# CITY OF BURLINGTON DEPARTMENT OF PUBLIC WORKS

Re: Proposed Safety Enhancements for Section C6 of the Champlain Parkway

# **Design Memorandum**

Re: Design Concepts for C-6 Section of the Champlain Parkway

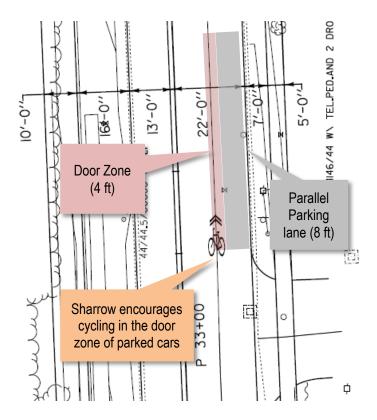
The proposed typical cross section of Section C6 is shown below.

The safety of this treatment can be improved by introducing design elements that will encourage cyclists in the northbound shared lane to stay out of the door zone of the parallel parked cars.

- Apply Cross Section A to Pine Street between Lakeside and the shared use path terminus at the Kilburn/Pine intersection. Also use Cross Section A on Pine Street between Maple Street and Main Street.
- Between the Shared Use Path terminus and Maple Street, apply Cross Section B.
- Give consideration to use of colorized asphalt for the buffer, which will keep bicyclist out of the door zone, and also visually narrow the appearance of the road. For this reason, the narrow shoulder on the west side of Pine St should also be colorized.

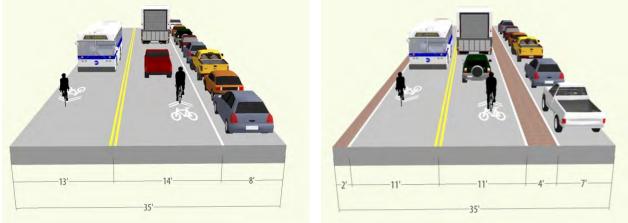
The sketchup renderings below show the current and proposed alternative treatment for Pine Street, looking north. The street's center line is the same location, but the pavement treatment provides important cues to motorists and cyclists that will increase safety by actively directing bicyclists to avoid the door zone. The parking lane is striped at 7 feet in order to encourage parking as close to the curb as possible. A four foot wide buffer keeps cyclists out of the door zone, which should be colorized asphalt. The sharrow markings show both cyclists and vehicle drivers where bicyclists should ride.
